WCAP-16793-NP, Rev.0 (Non-Proprietary)
Project No. 694

March 2, 2009

OG-09-84

Subject: Pressurized Water Reactor Owners Group
Responses to the NRC Request for Additional Information (RAI) on WCAP-16793-NP, "Evaluation of Long-Term Cooling Considering Particulate, Fibrous and Chemical Debris in the Recirculating Fluid" (PA-SEE-0312)

Figure 8: Integrated Core Flow vs. Core Boil-off for Channel 13 Flow Reduction 80% Case

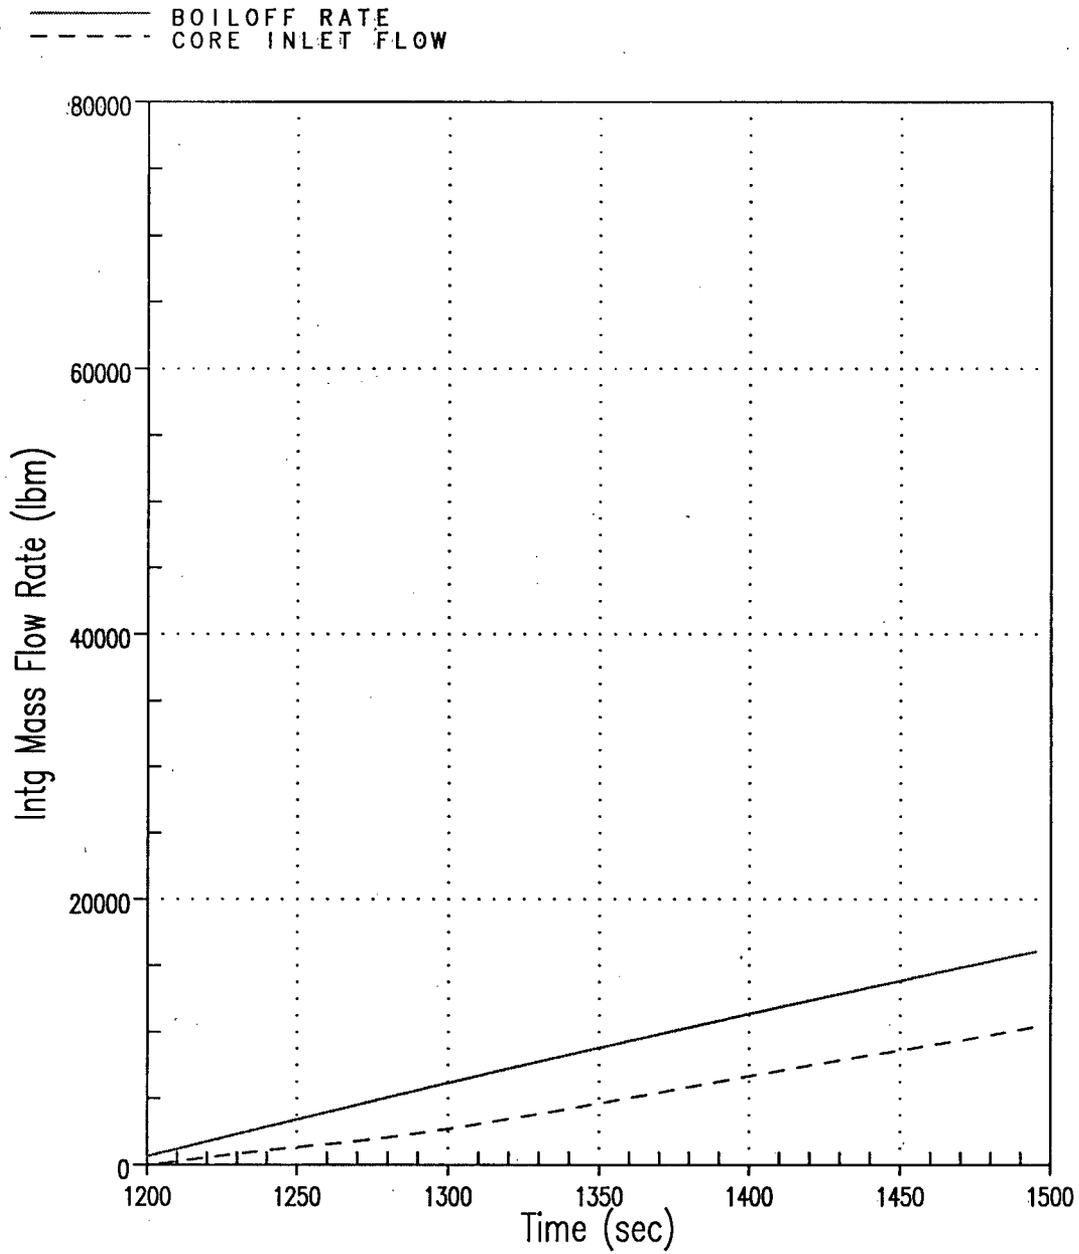
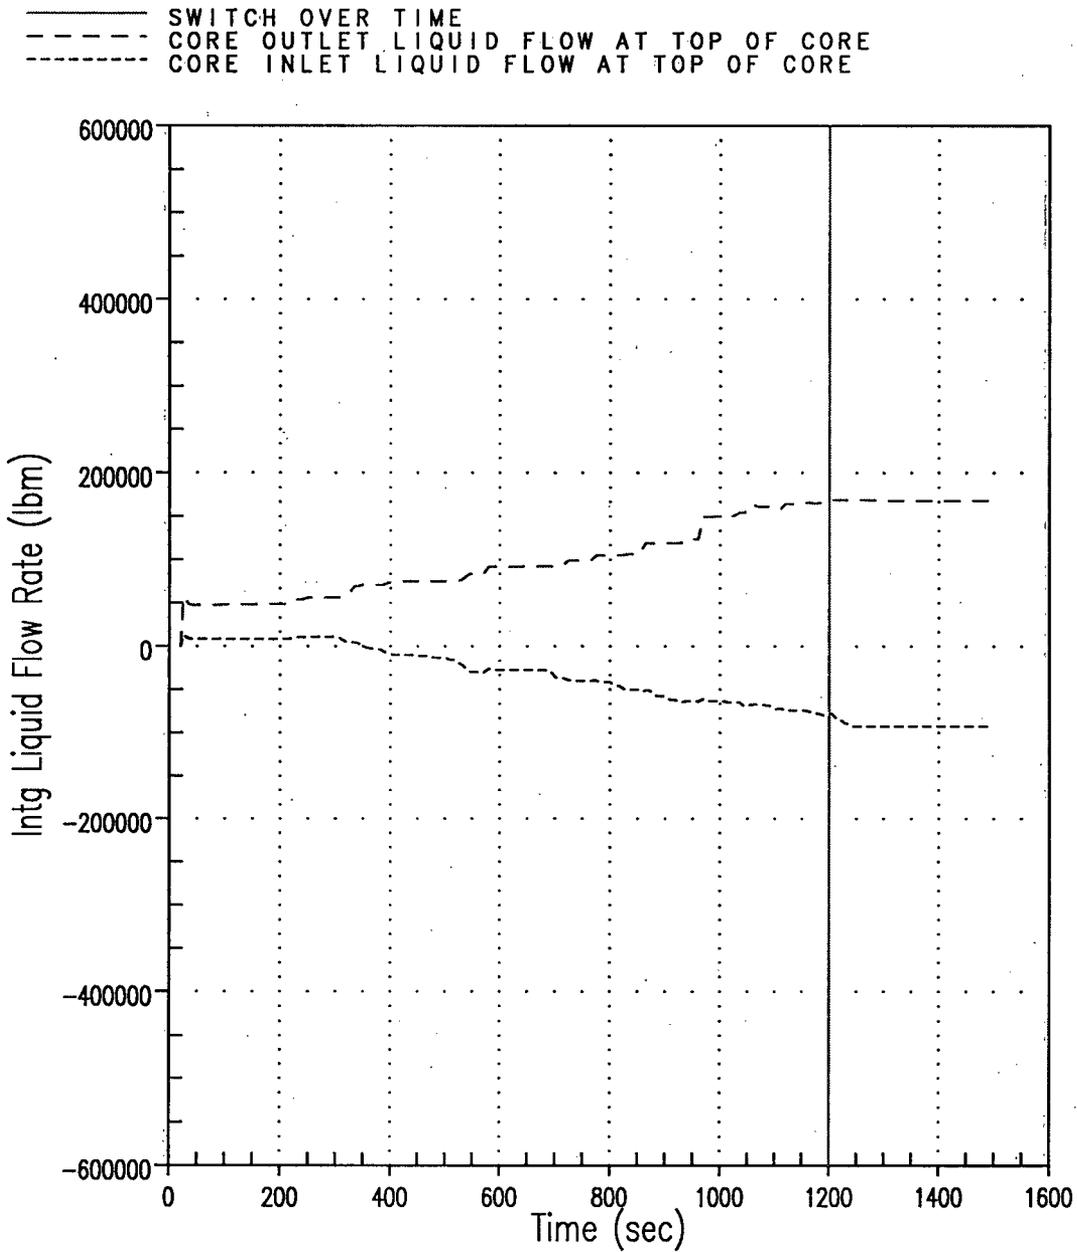
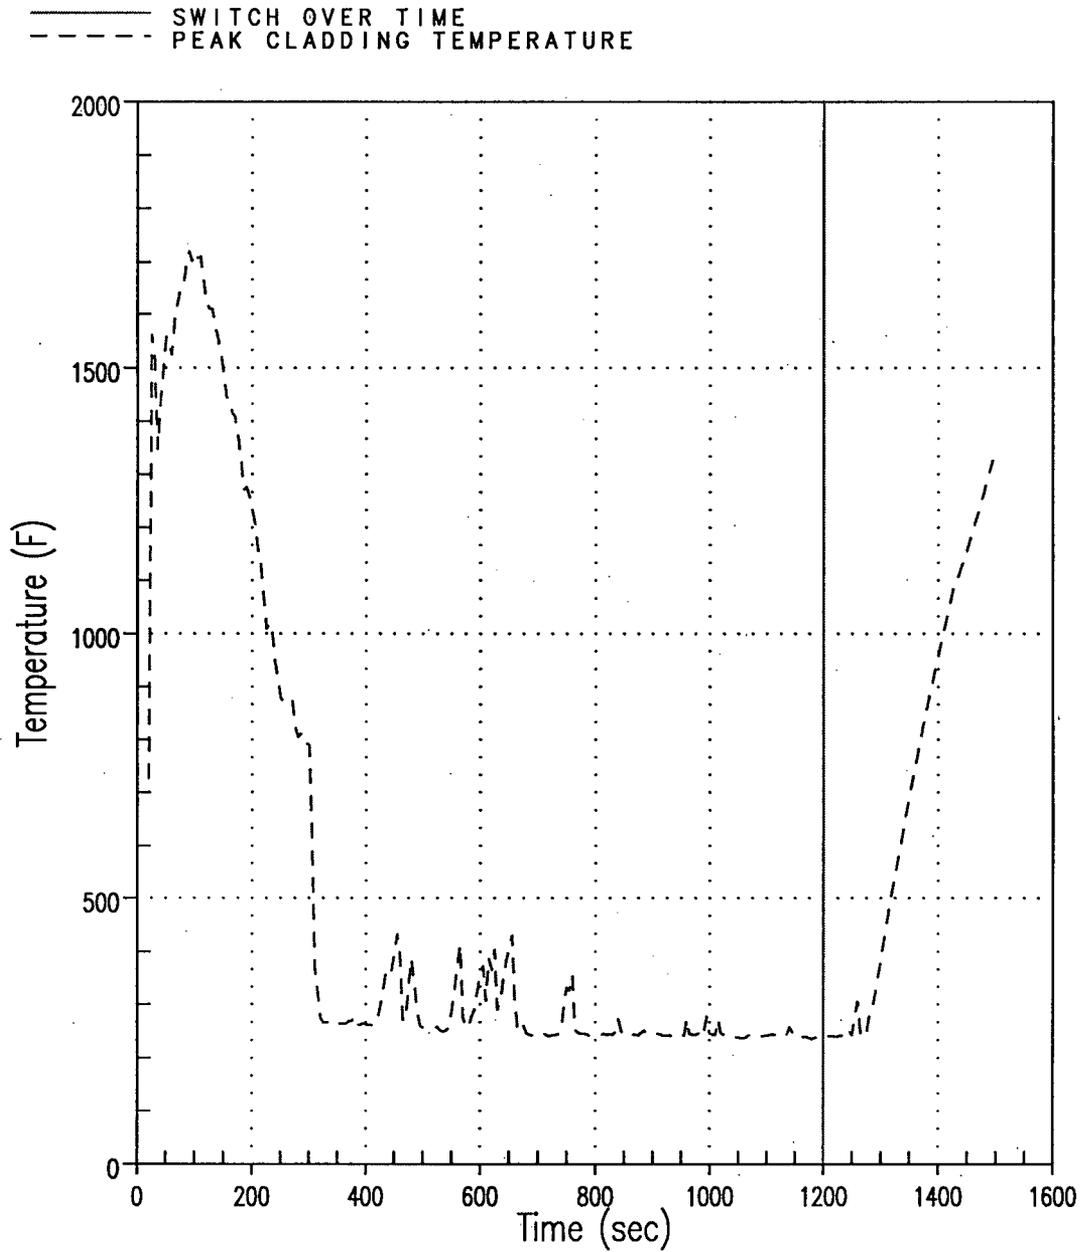
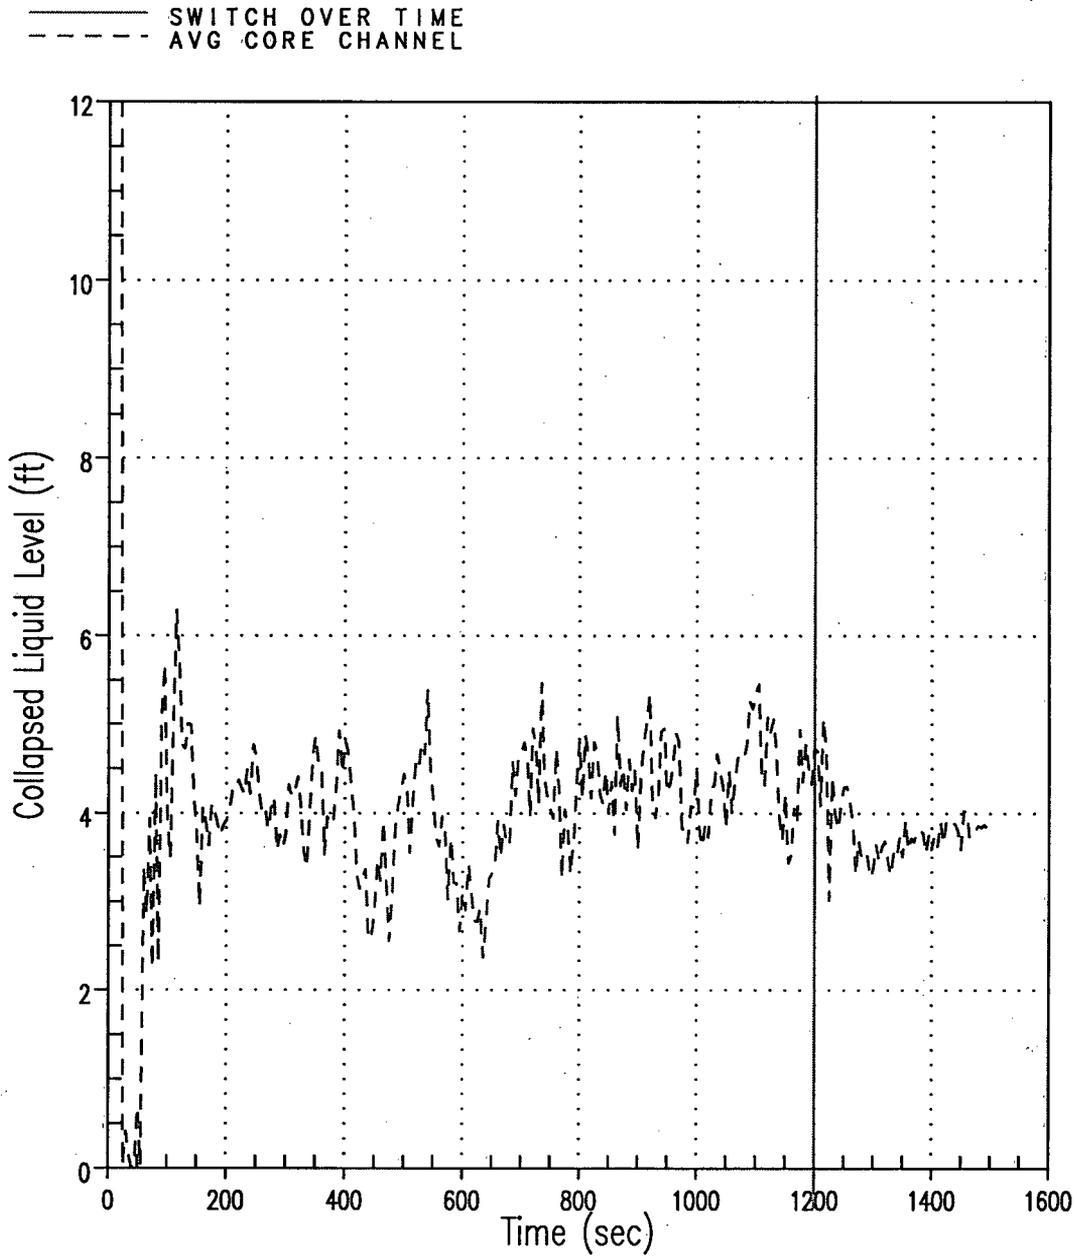
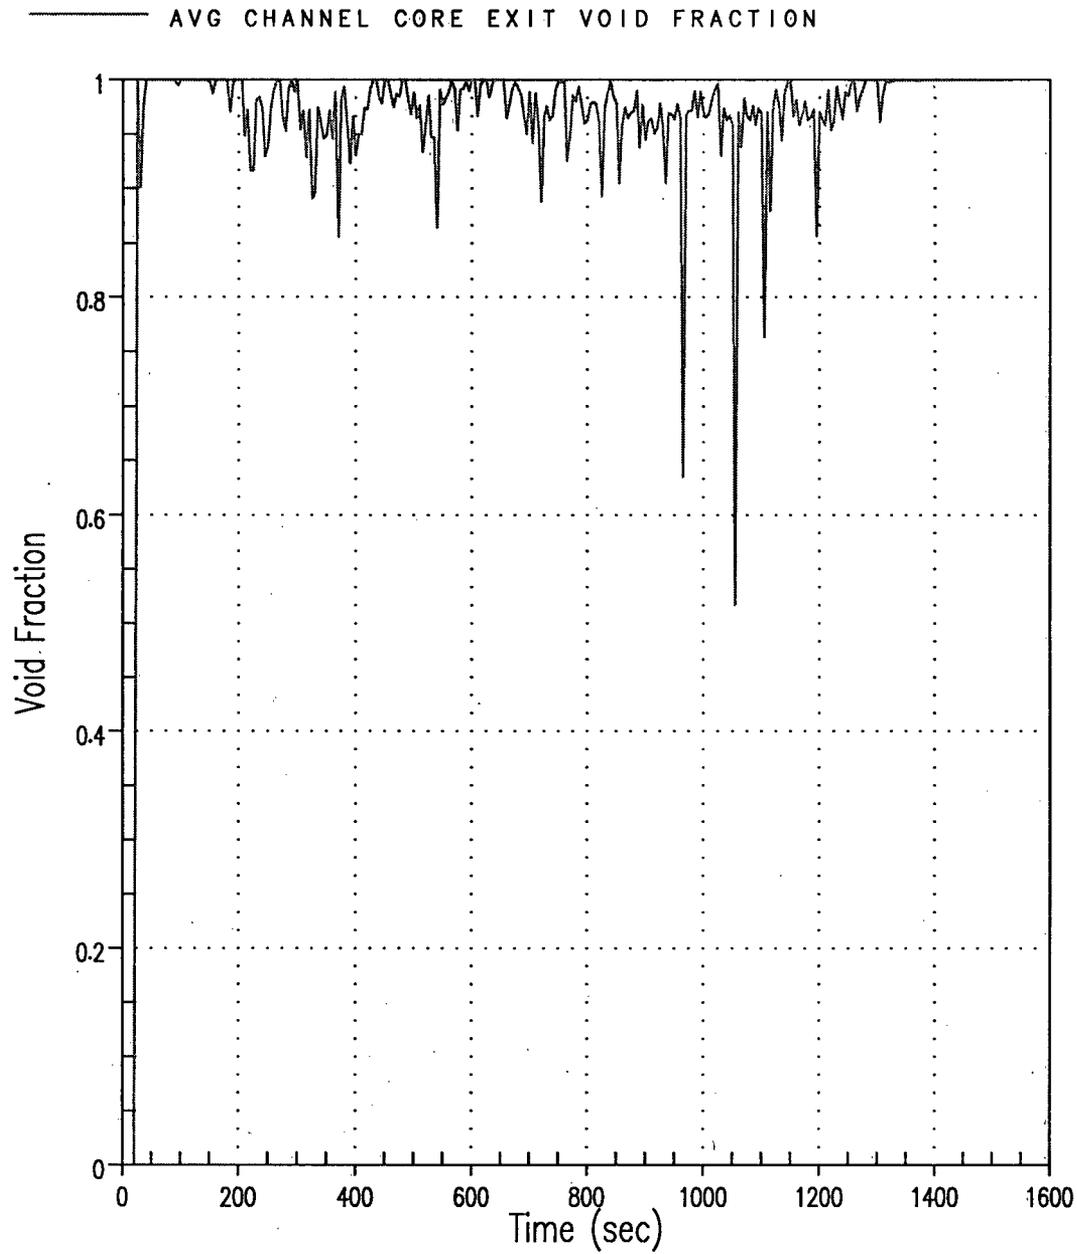
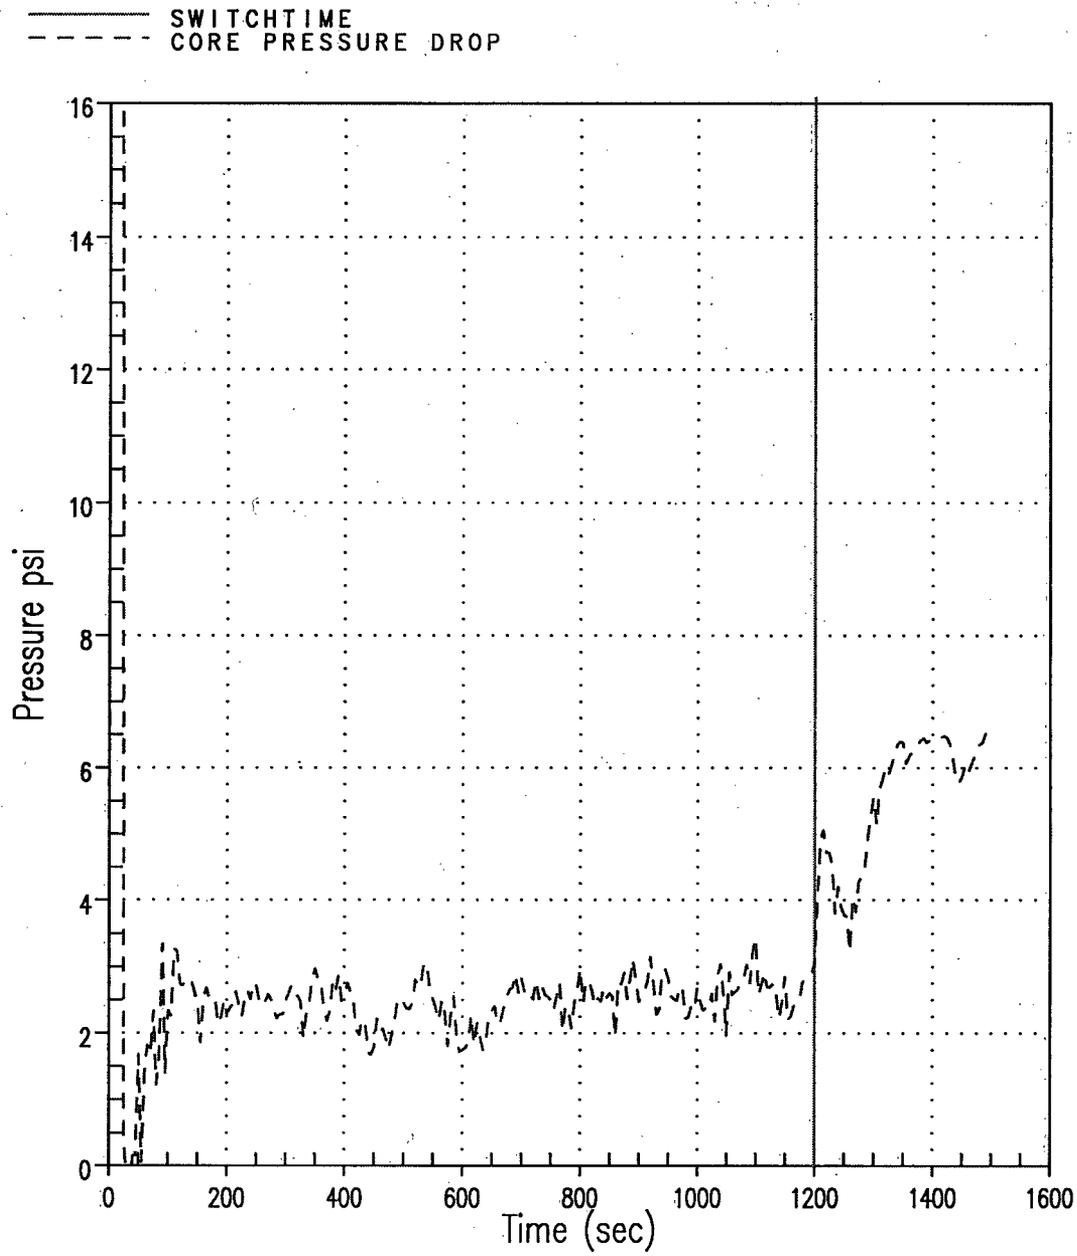
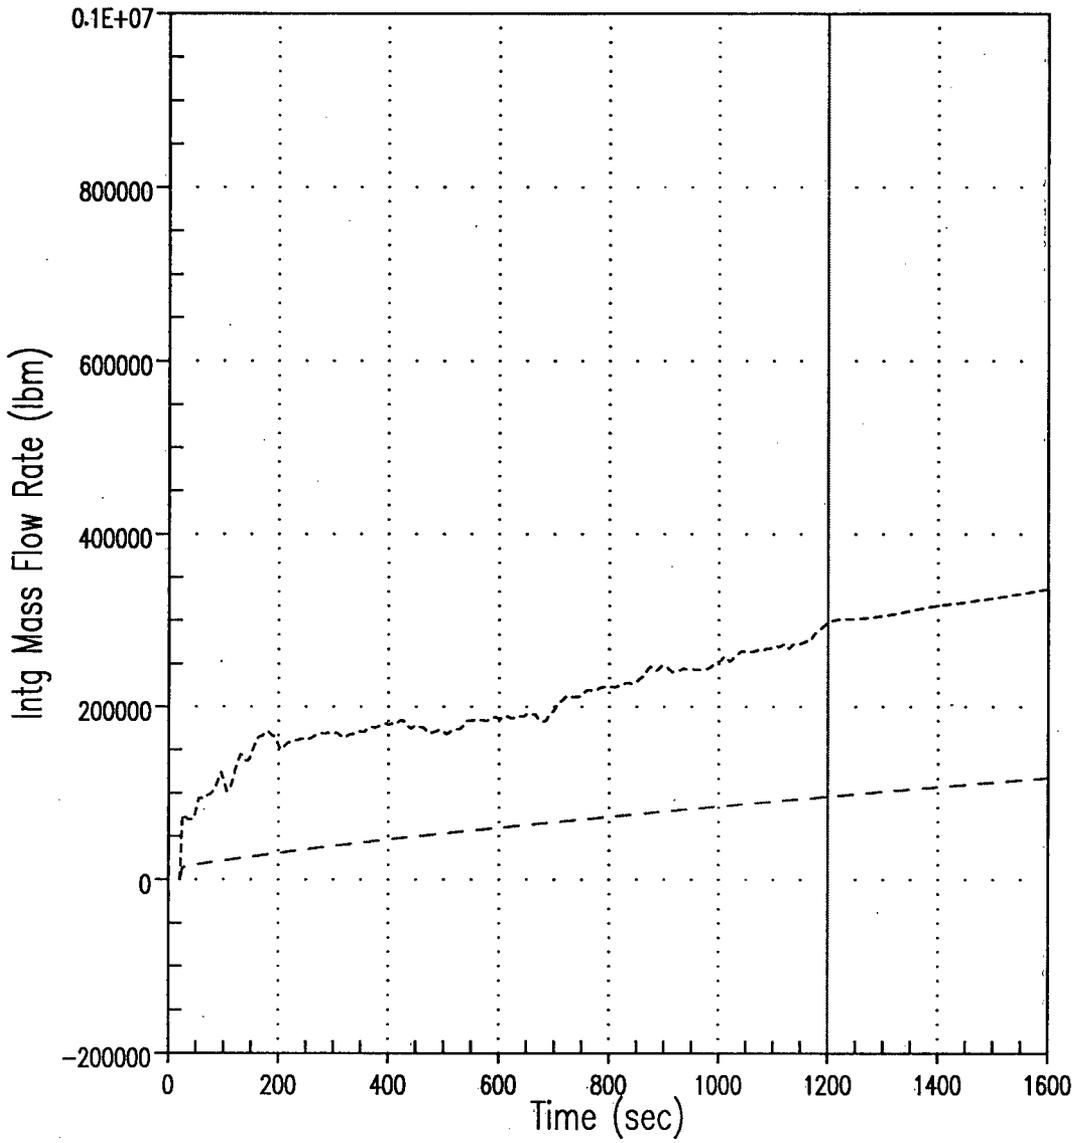
- 1) WCAP-16793-NP, Appendix B, presents analyses of the effect of core inlet blockage using the WCOBRA/TRAC analysis code. Since the report was prepared additional analyses have been performed to determine the blockage level that would reduce core flow below that necessary to match coolant boil-off. Please provide documentation of the additional analyses that have been performed, including figures, for the integrated core inlet and exit flow, peak cladding temperature, core collapsed liquid level, core exit void fraction, and core pressure drop for the bounding conditions. The results should be presented for each case analyzed up to and including the blockage level for which boiloff is no longer satisfied.

The next flow reduction run performed reduced the hot channel (Channel 13) flow area by 80%, which yields a total core inlet flow area reduction of 99.9%. The requested plots for this case are shown in Figures 8 through 14. Figures 8 and 9 show comparisons of the integrated core inlet flow and boil-off rate. As shown, with the increase in core blockage, the flow that enters the core can not match the boil-off rate. Since all the liquid entering the core at the inlet is boiled-off, there is no liquid flow at the core exit (as shown in Figure 10). In addition, Figure 11 shows that the PCT increases until the end of the transient once the core liquid level, shown in Figure 12, is reduced to a level that the core becomes unquenched. Continuing with the trend discussed above, the void fraction at the core exit (Figure 13) shows that only vapor is present. The core pressure drop is displayed in Figure 14. The figure displays an increased pressure drop of roughly 4 psi as blockage at the core inlet is increased and the core liquid level begins to stabilize.
